31398 Huntwood Ave. Hayward, CA 94544 (510) 576-2220 <a href="http://www.gelpak.com">www.gelpak.com</a>	
		Description: <b>GEL-PAK Print# P-0041 (20 x 20)</b>	
Part # P-0041		Rev: 2	
Dwg # P-0041_AD-22.ai		Date: 08/25/11	
Scale: 1:1	Dimensions: inches	Sheet: 1 of 1

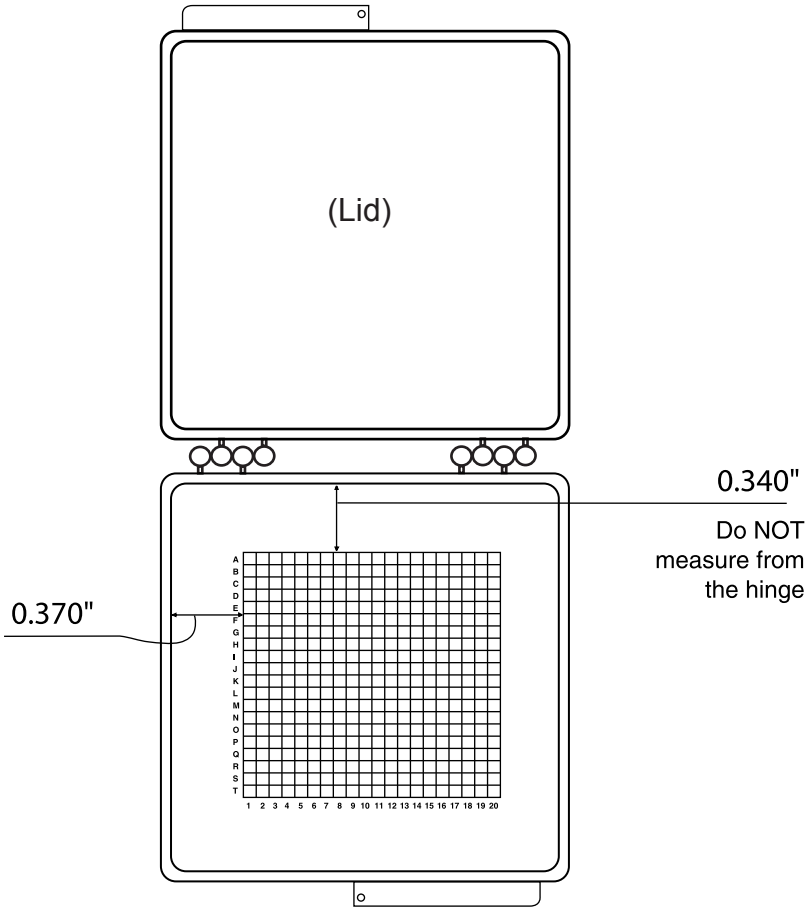
Revision History			
Rev.	Description	By	Date
1	Initial Release	N/A	09/20/02
2	cell dim. .060" is actually .057" & line weight 0.010" is actually 0.007", chg to meet manuf. practice	PM	08/25/11

- 1) Cell Size: 0.060" x 0.057"
- 2) Line Weight: 0.007"
- 3) Font: Helvetica Bold 3 pt.
